Applies To: **2004–05 TL – ALL**
2006 TL – From VIN 19UUA6...6A000001 thru 19UUA6...6A076363

August 16, 2007

Outer Door Handle Extension Falls Off

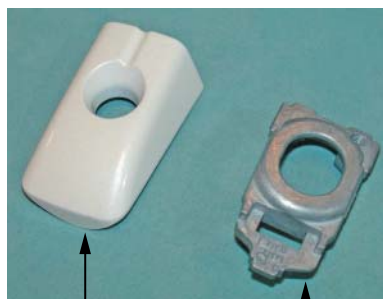
SYMPTOM

The outer painted cover of the door handle extension falls off.

The extension (cover) and its base (holder) do not fit correctly.

Replace the affected extension (cover) and its base.

NOTE: The extension and its base *must* be replaced together.
